MEMORANDUM

TO: Douglas DeKoskie, New York City Department of Environmental Protection

FROM: James Murac, P. E., Milone & MacBroom, Inc.

RE: NYSDOT Options for Route 23 Bridge Replacement
Prattsville, New York
MMI #3597-19-2

DRAWING NAME:
FIG. 1

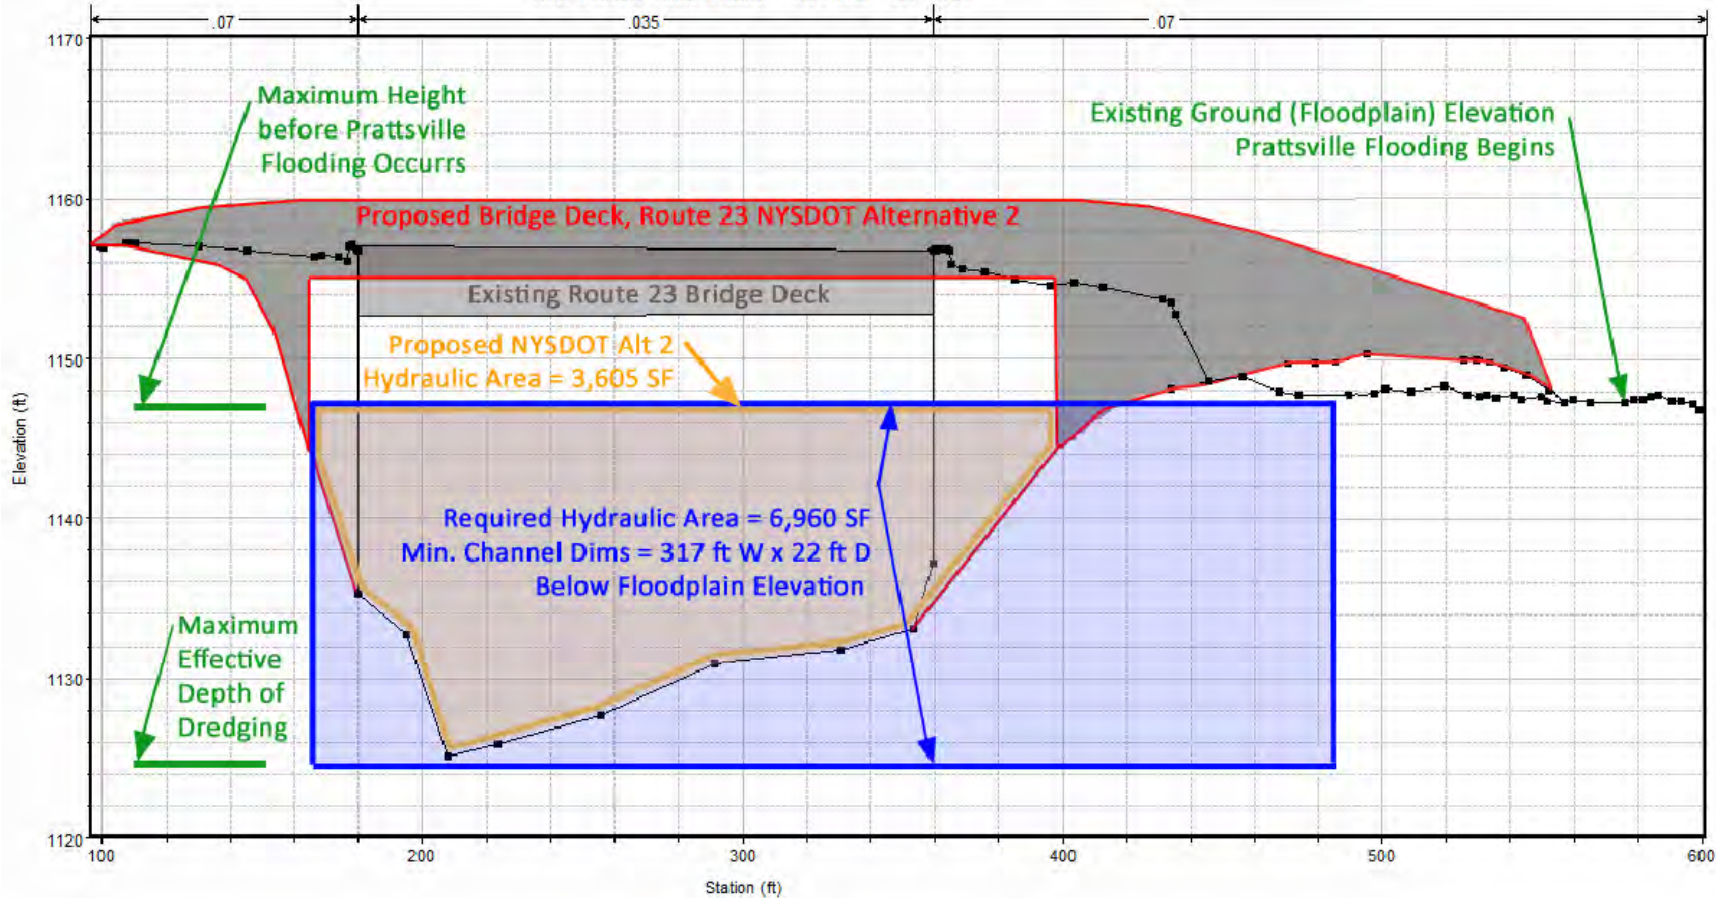
The bridge replacement options assessed by NYSDOT do not provide adequate span to accommodate a future channel widening as evaluated by MMI and would prevent such work from being completed in the future. Figure 1 presents a schematic cross section that compares the existing bridge and the NYSDOT replacement Option 2.

FIG. 3

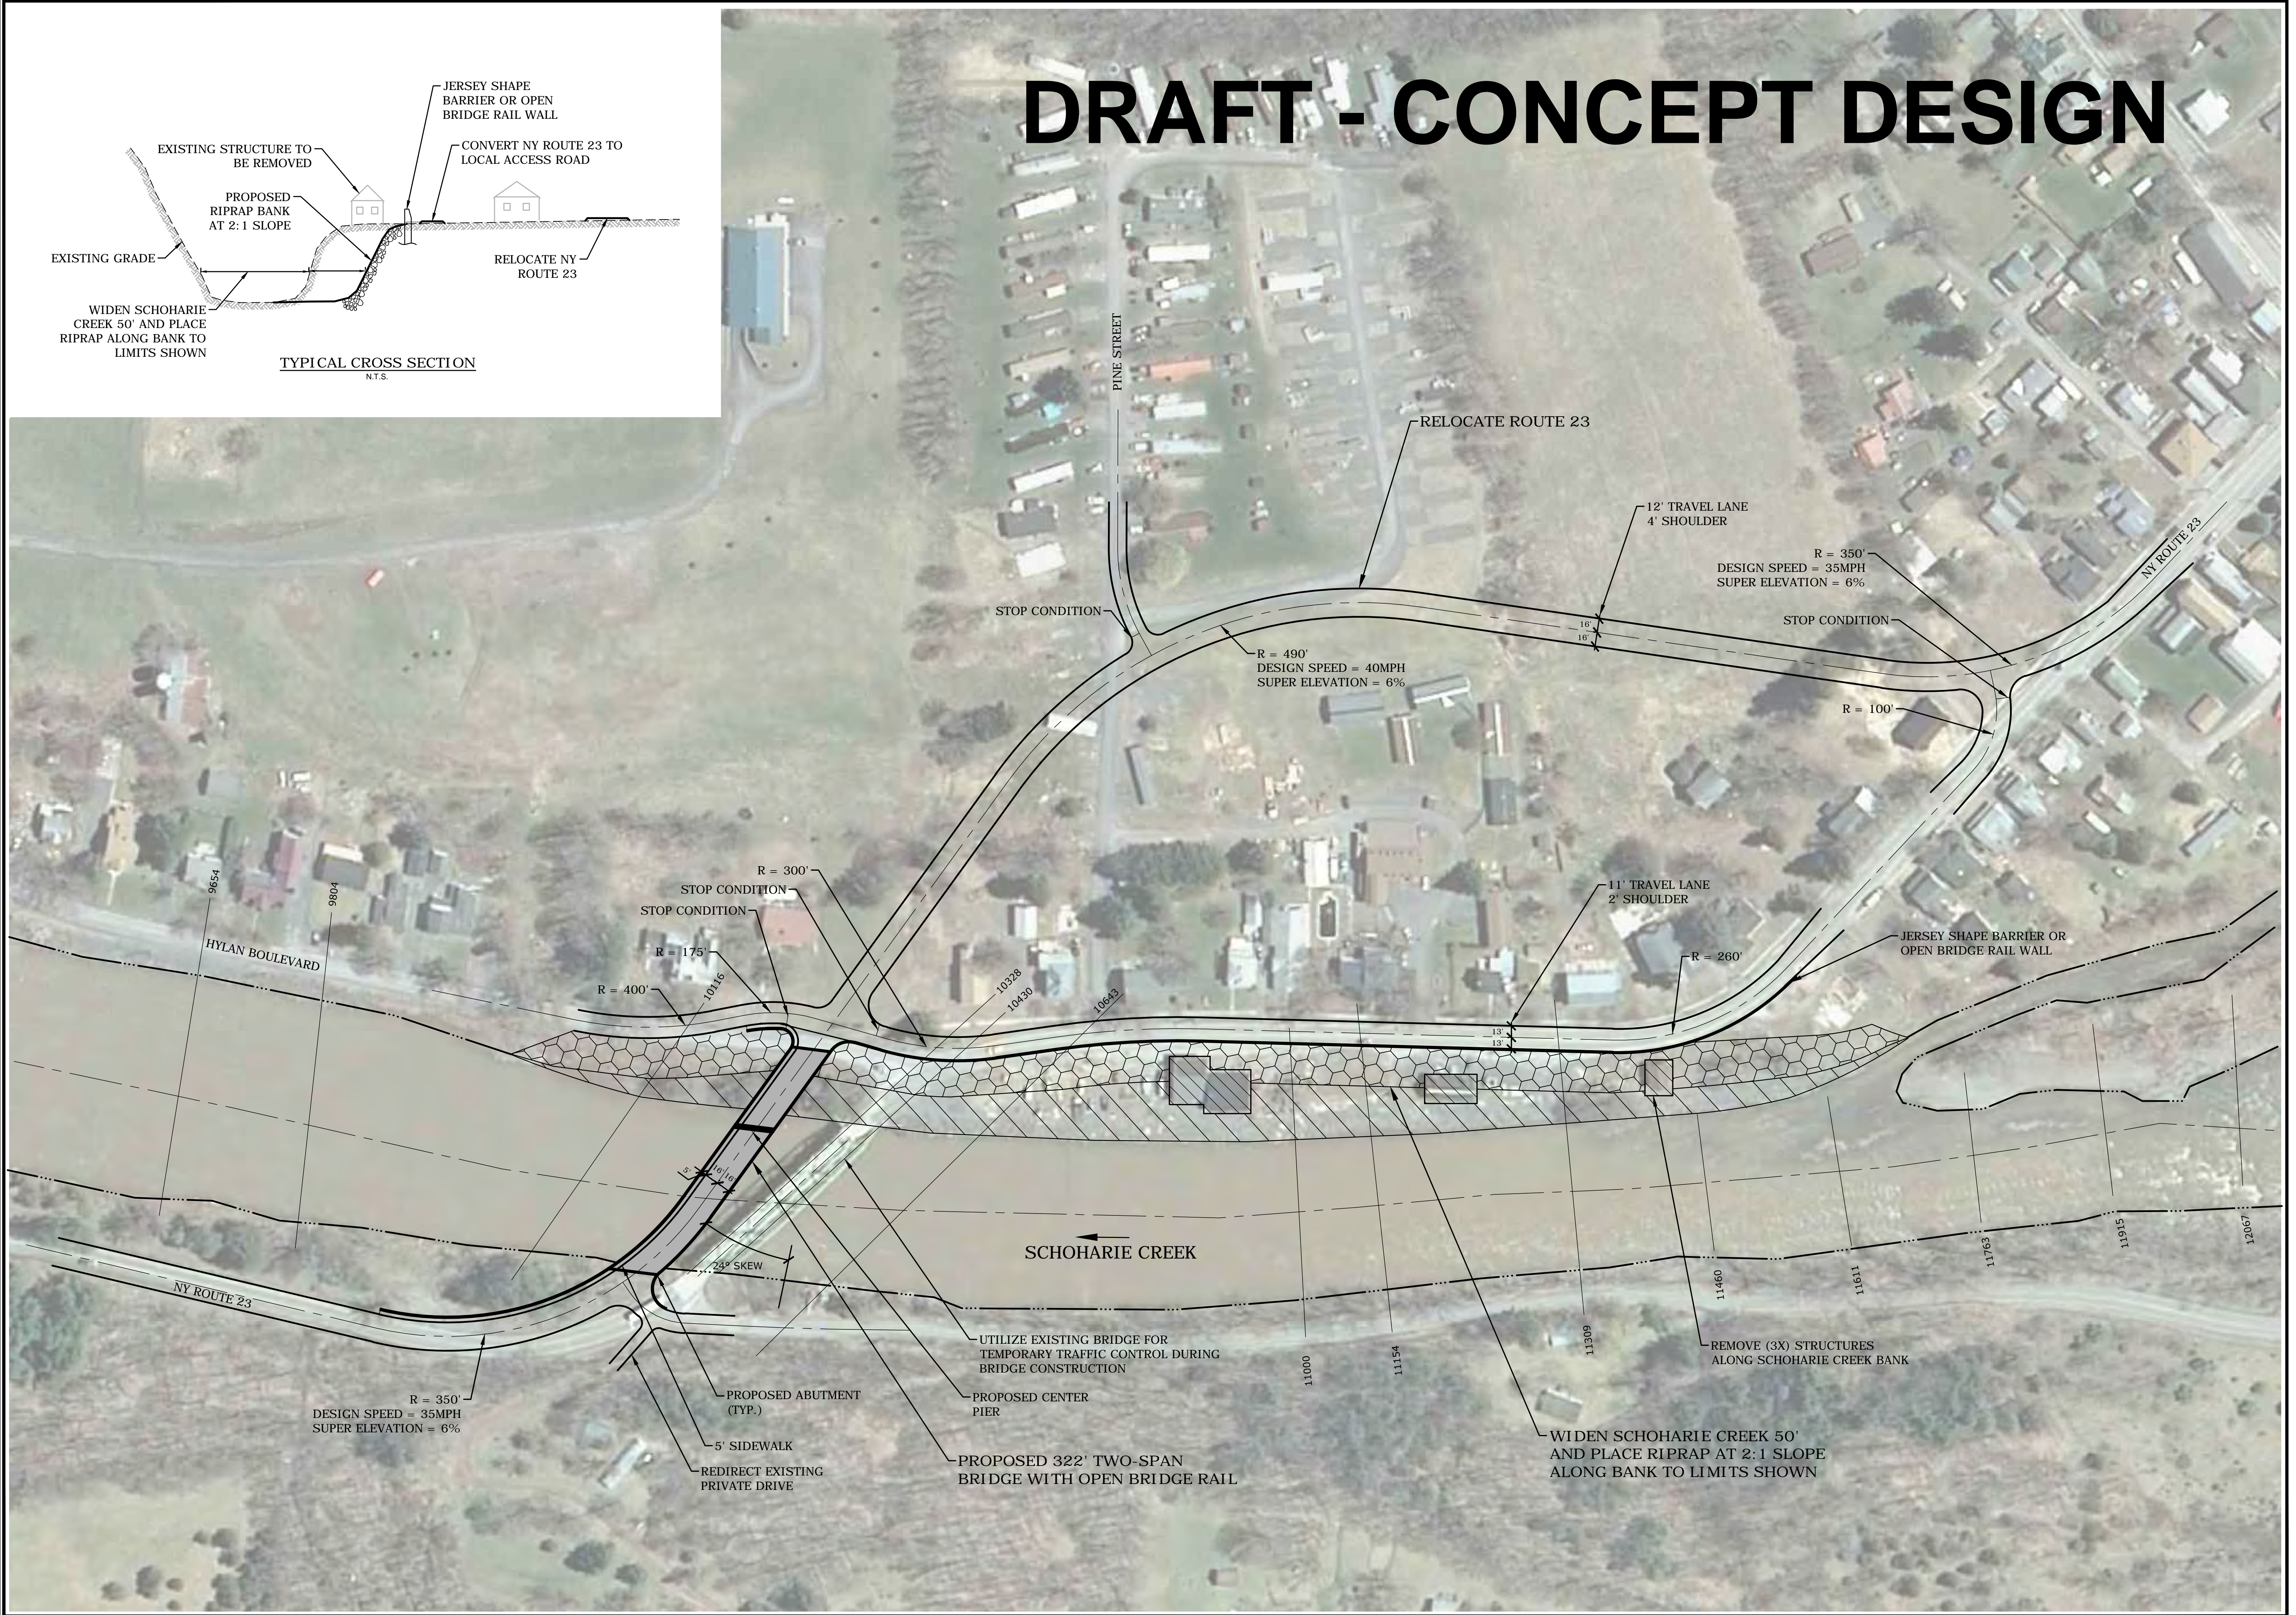
Figure 3 presents a hybrid alternative that reduces the skew angle of the crossing to 24 degrees (effective width of 294 feet) and replaces the truss structure with a 322-foot-long two-span bridge with an open bridge rail. The new bridge would be located downstream of the existing crossing such that the existing bridge can be used during construction. The new bridge would be constructed with a pier to provide two smaller spans. Construction of a two-span bridge rather than a truss bridge has the potential to provide an overall cost savings. The alternate structure enables widening of the Schoharie Creek upstream, similar to what was modeled under the MMI Alternative 4.

The channel widening plan presented in Figure 3 is conceptual in nature. The overall amount of channel widening varies and is maximized to the extent that seems feasible while minimizing impacts to existing structures. Although 320 feet is the preferred channel width, this was not possible at all locations. The widening involves the relocation or removal of three structures along the eastern bank of Schoharie Creek.

DRAWING NAME:
FIG. 2

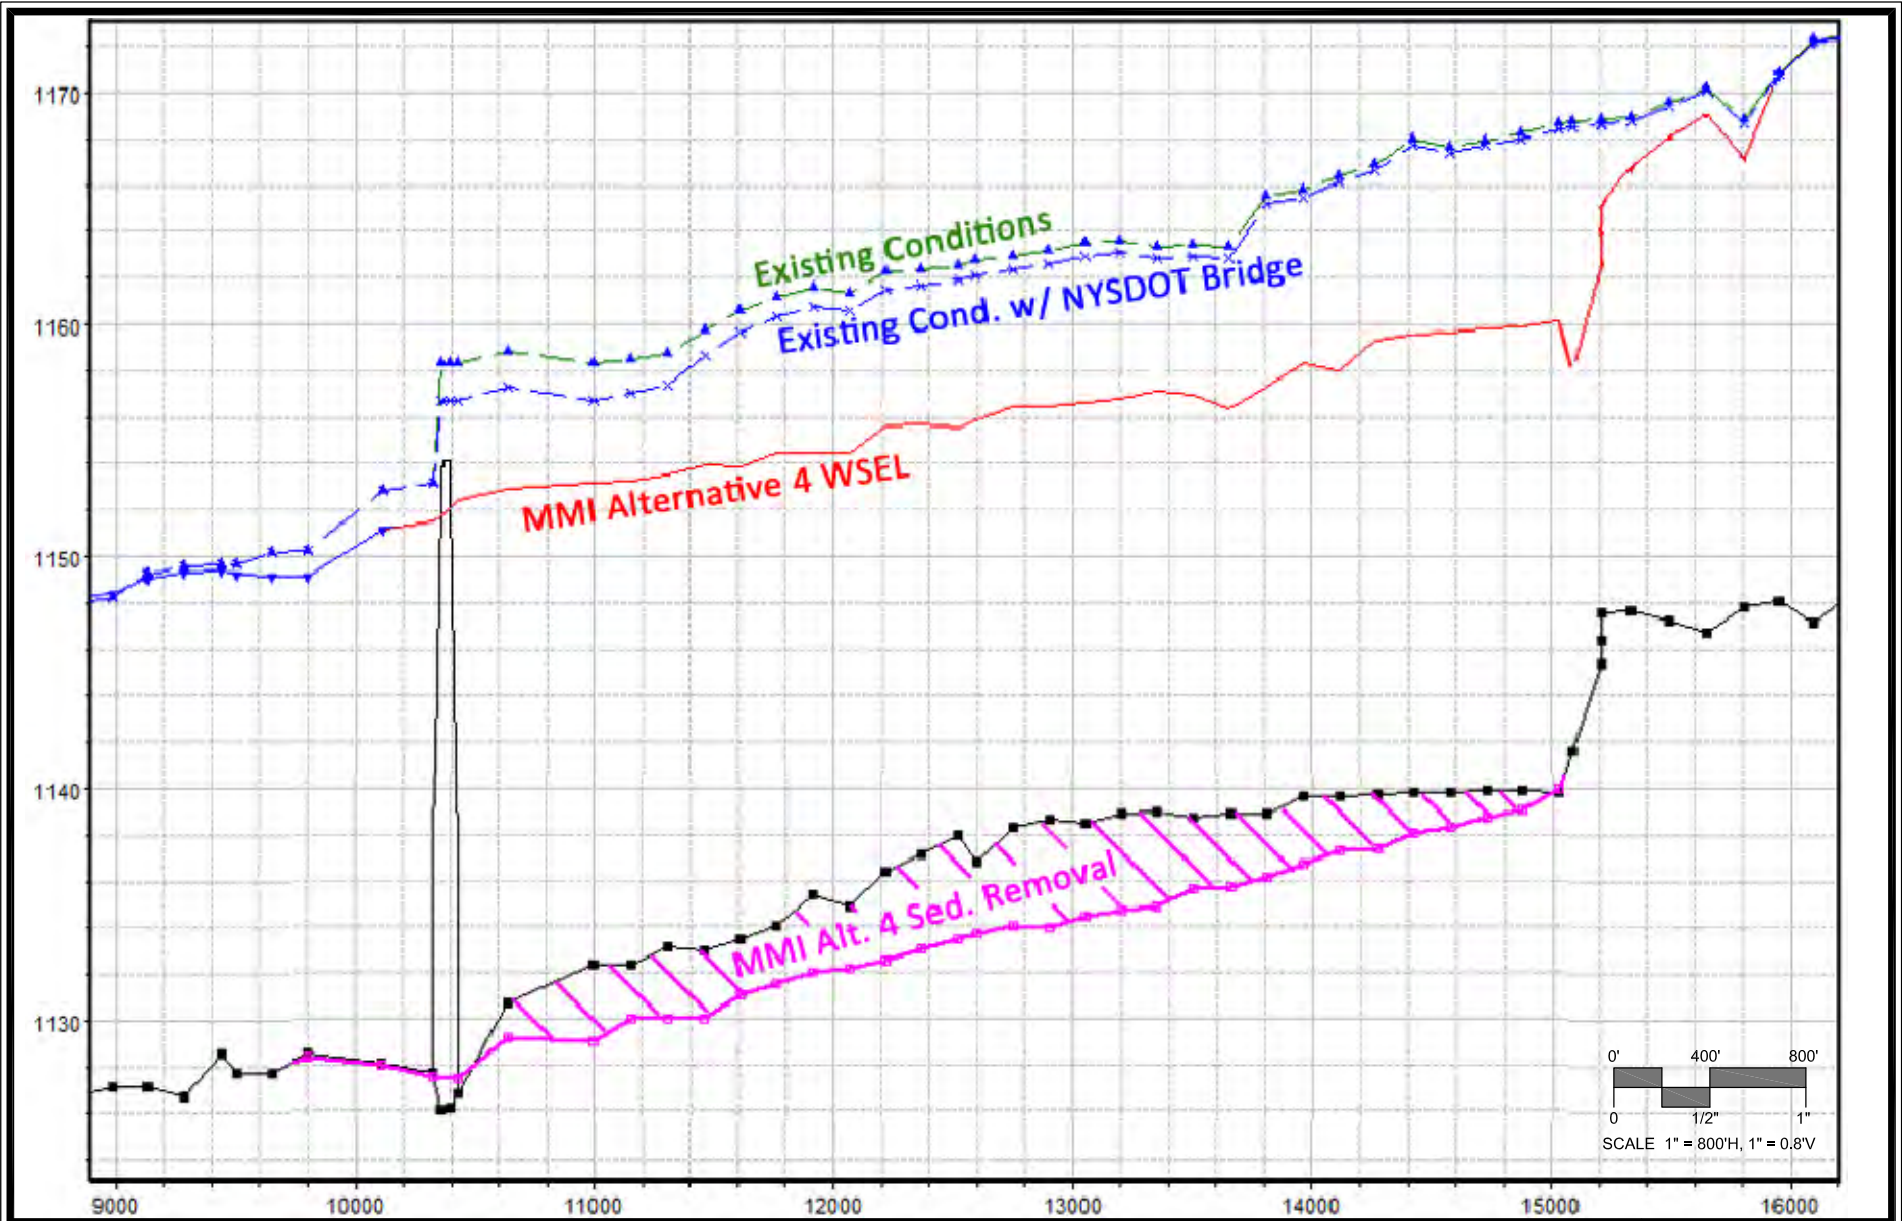
Figure 2 presents a profile generated from the HEC-RAS model output comparing the MMI modeled existing conditions, NYSDOT Option 3, and the MMI Alternative 4.
